GS# 362-066 West Lot Improvements (Paving and Renovations (Phase 1))

Woolfolk Building (Office of Capitol Facilities) (Department of Finance and Administration)

Addendum No. 2

RFI #1

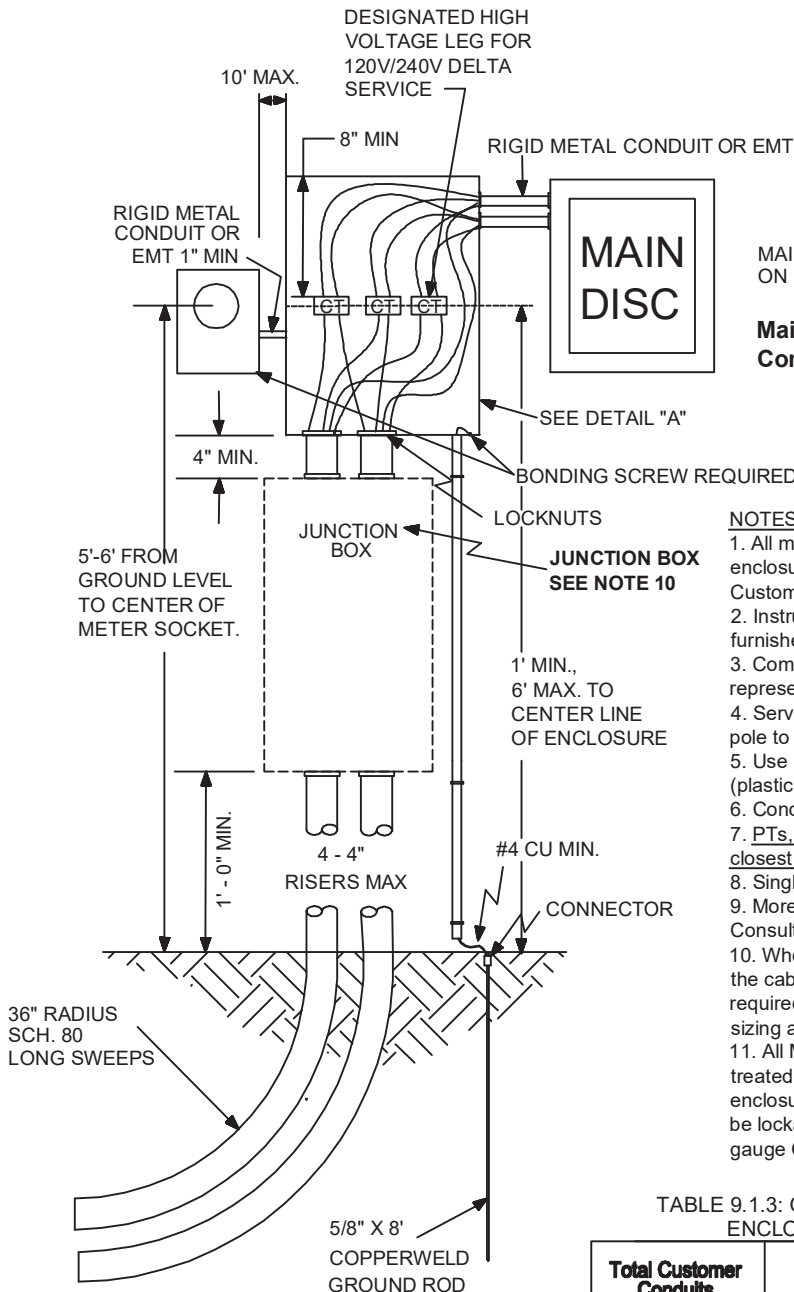
Plan/ Sheet/Spec	Item #	Requested Information	Response
E-501 Electrical Riser Diagram	1	Typically Entergy requires an exterior Main Power Disconnect and a CT Cabinet for metering within 10' of the exterior Main. Please confirm that the indoor Main Breaker and CT Cabinet as shown on E101 and the Riser Diagram will be acceptable to the Utility Company. (See attached Drawings from Entergy's Customer Installation Standards for Electrical Services)	The Knox Box with Emergency Shutdown Switch is to shunt-trip the main breaker in MDP. This was coordinated with Entergy in lieu of an exterior disconnect.
26 32 13 1.2, A., 4 Generator	2	Does this generator include an integral load bank?	The generator does not have an integral load bank. The load bank reference in this section is just related to the load bank testing required in Section 3.5 C2.
26 05 01, 1.5, C., 1. Electrical Service Charge	3	Will it be possible to specify an allowance for charges by Entergy to furnish primary service and transformers? This will be an unknown amount until such time that Entergy's engineering team provides pricing.	The BoB does not permit this but we have reached out to Entergy and they have a price that they are able to share.

1 D100 GROUND FLOOR - EXISTING/DEMO
1/8" = 1'-0"

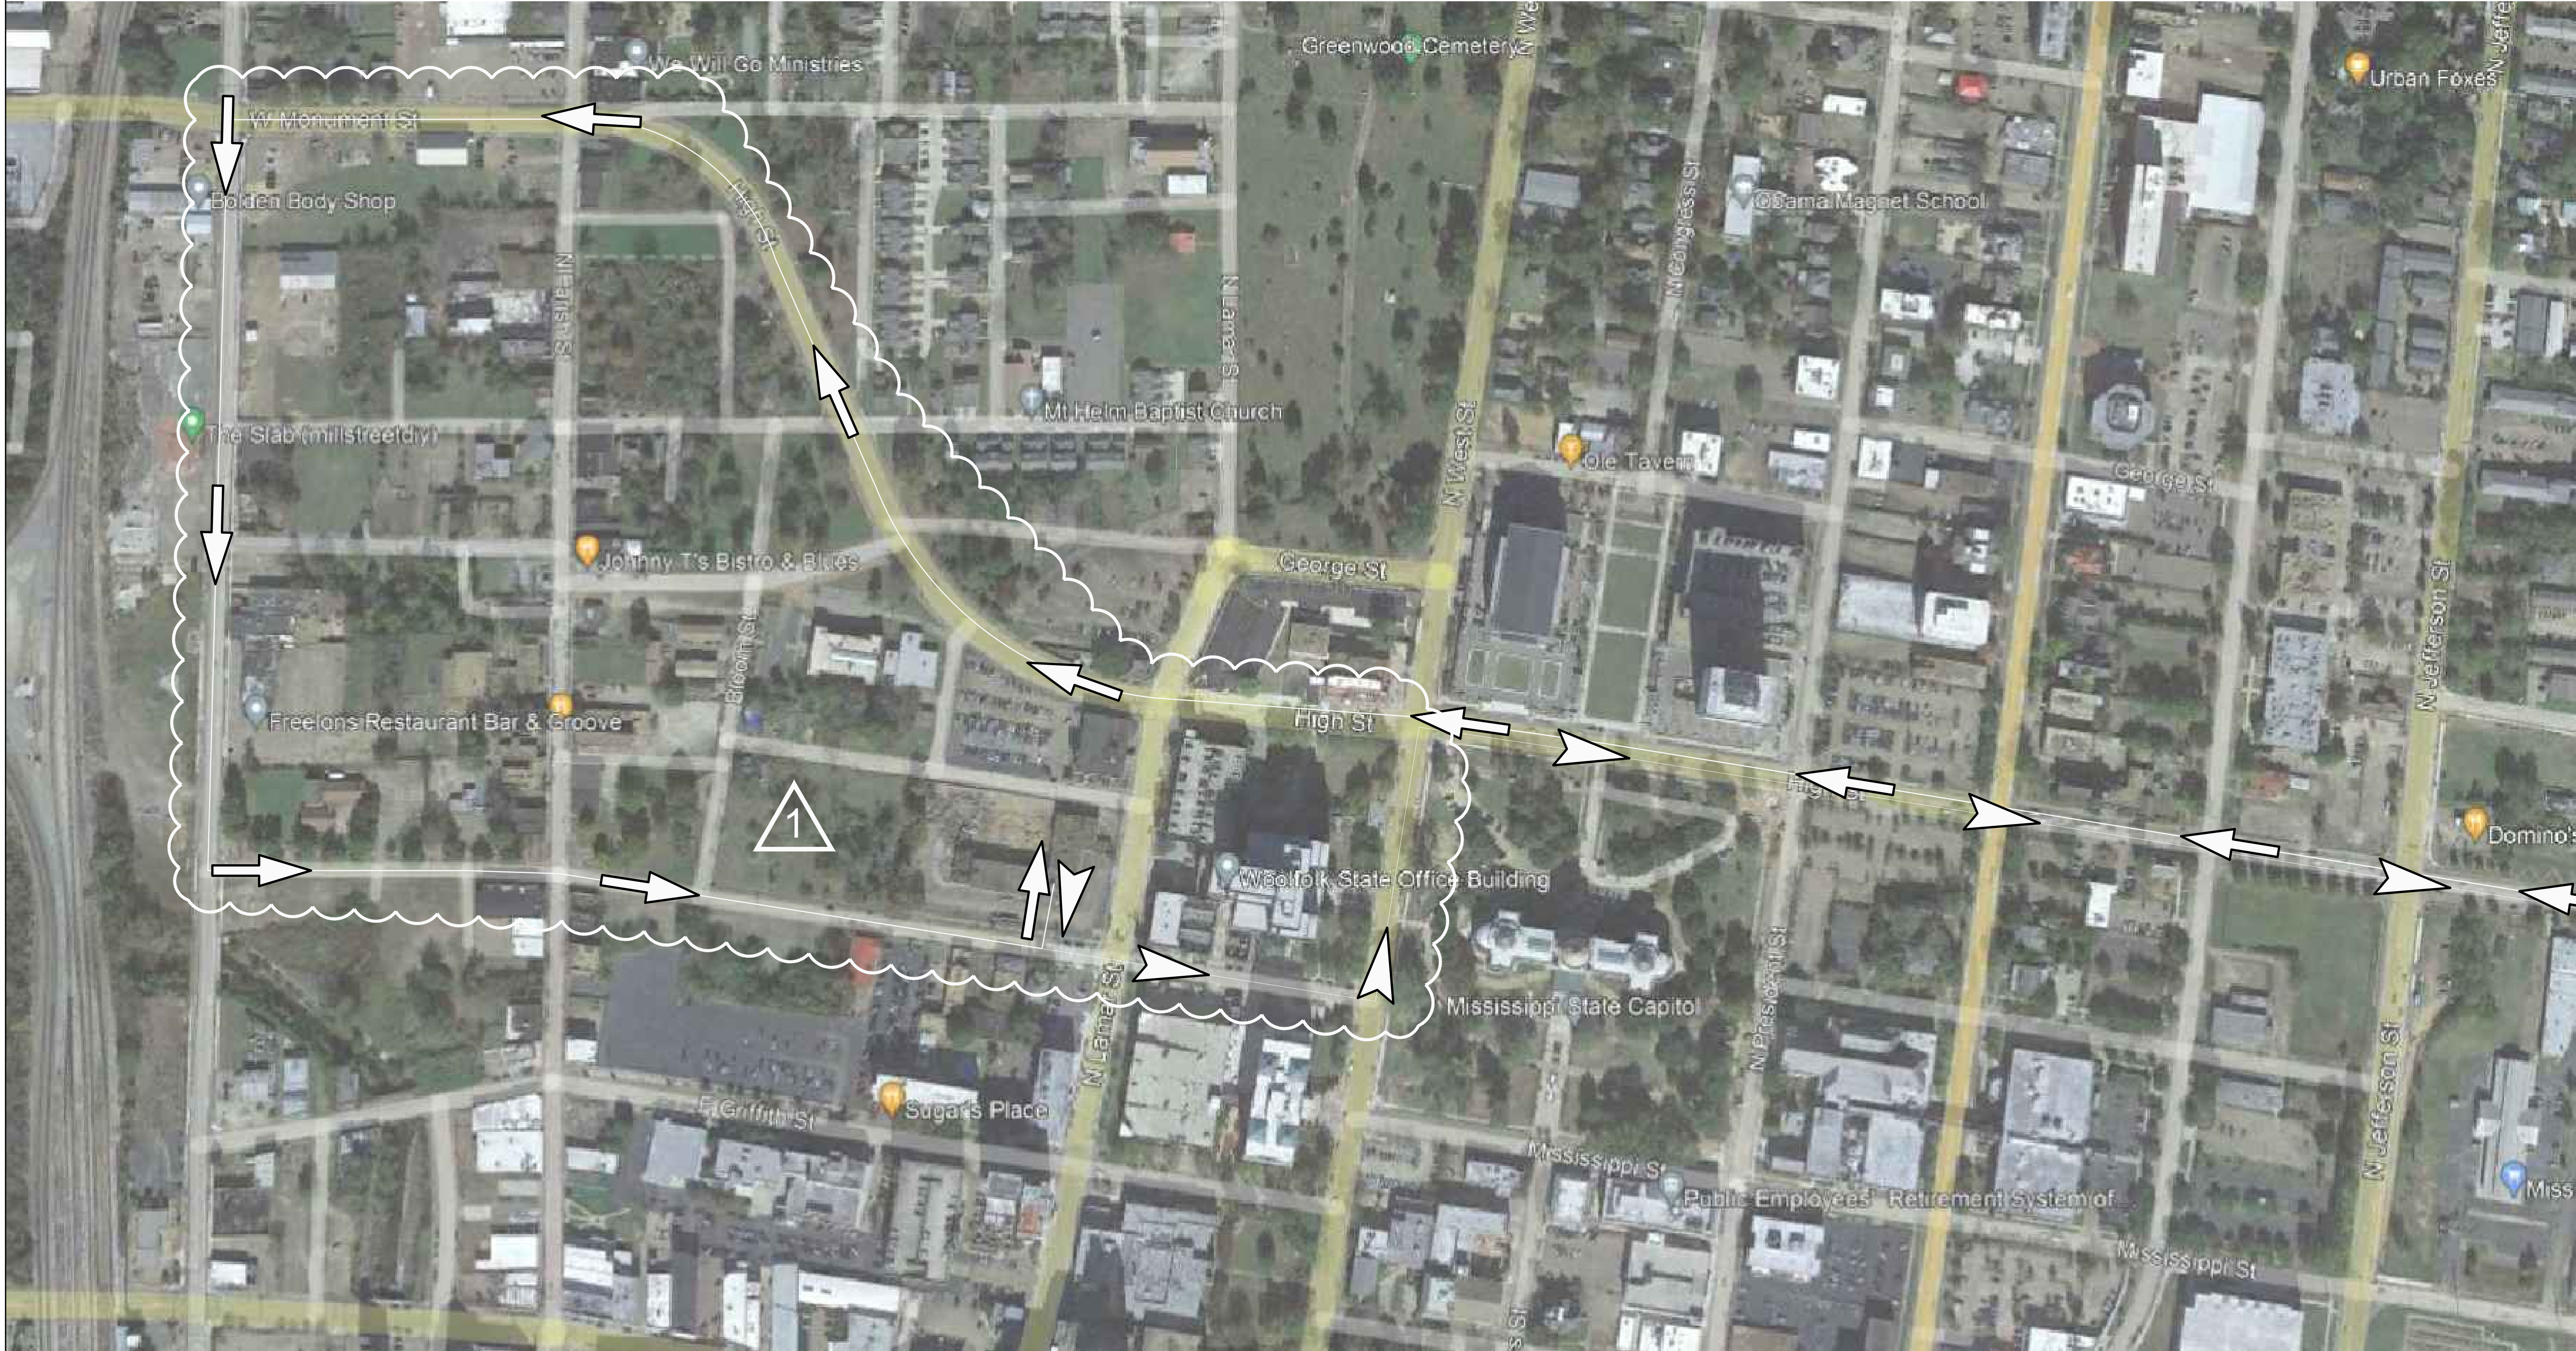
- a. D100 – REVISED 1/D100 to include demolition of portion of slab for new sub-grade conduit routing. See revised D100, attached.
- b. C1.1 – REVISE Construction Truck Routing Plan, see attached revised sheet

CONSTRUCTION
TRUCK ROUTE
PLAN

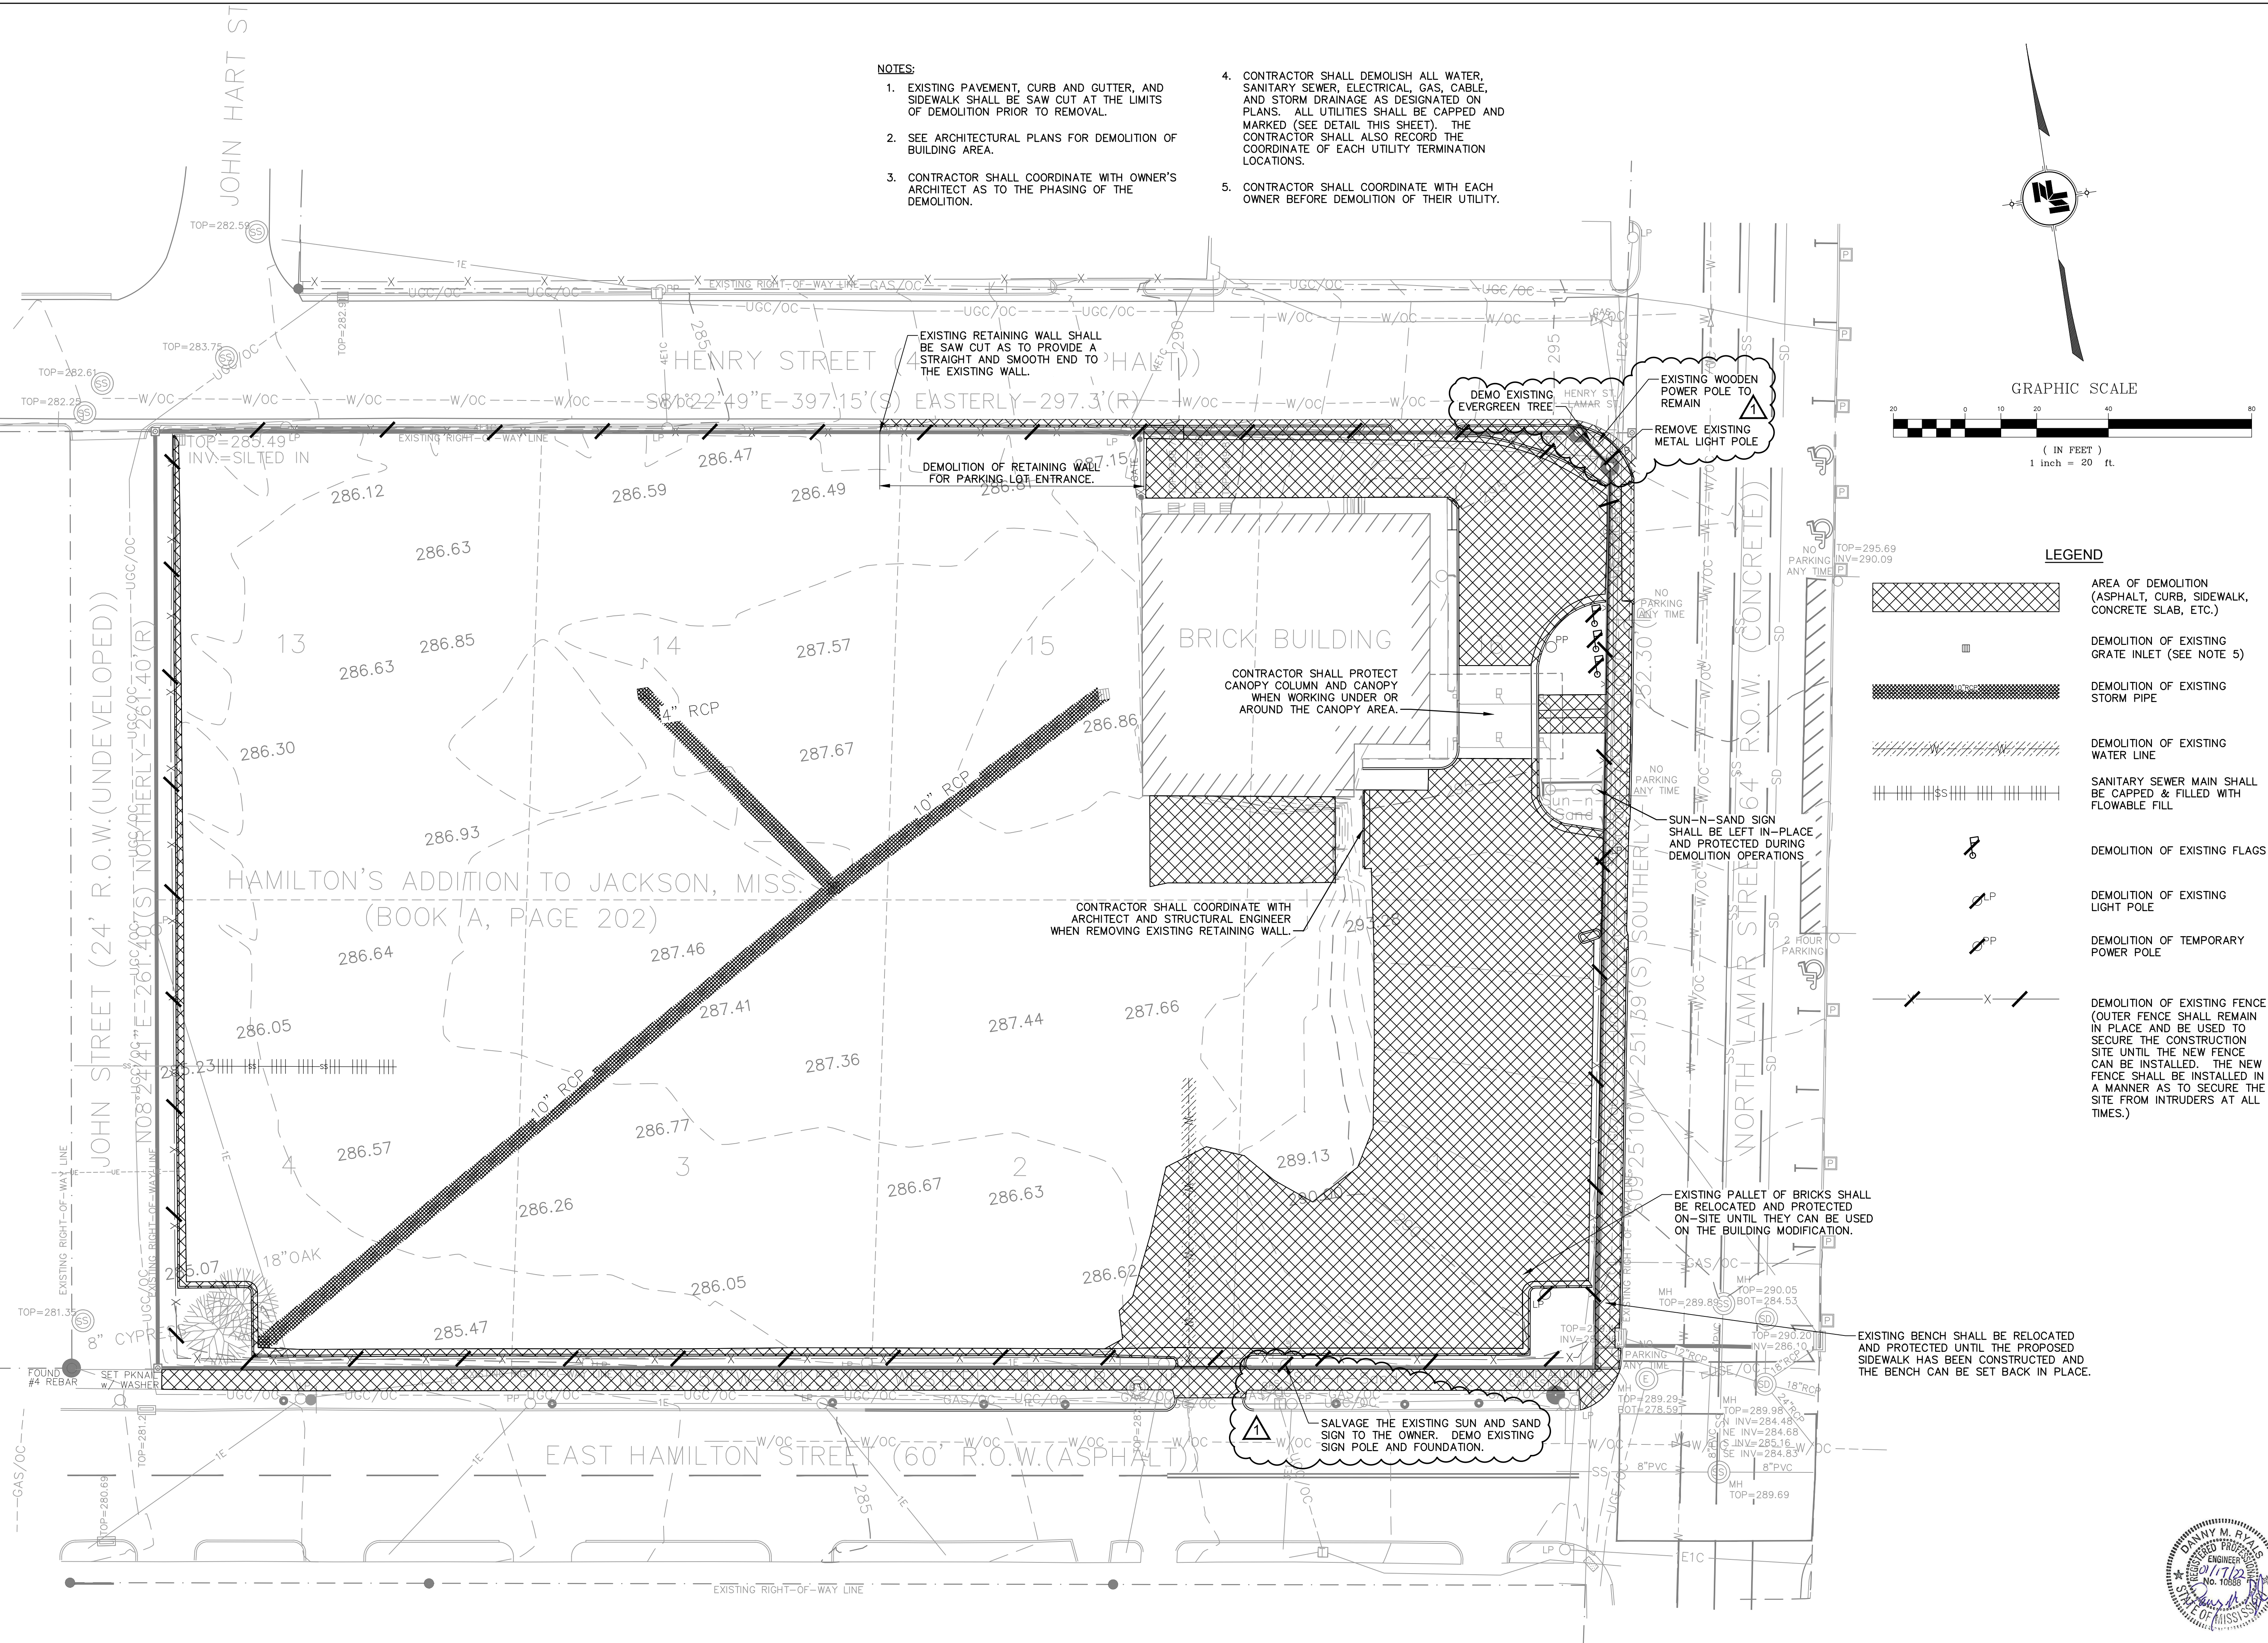
REVISIONS:
1/17/22 REVISED ROUTE
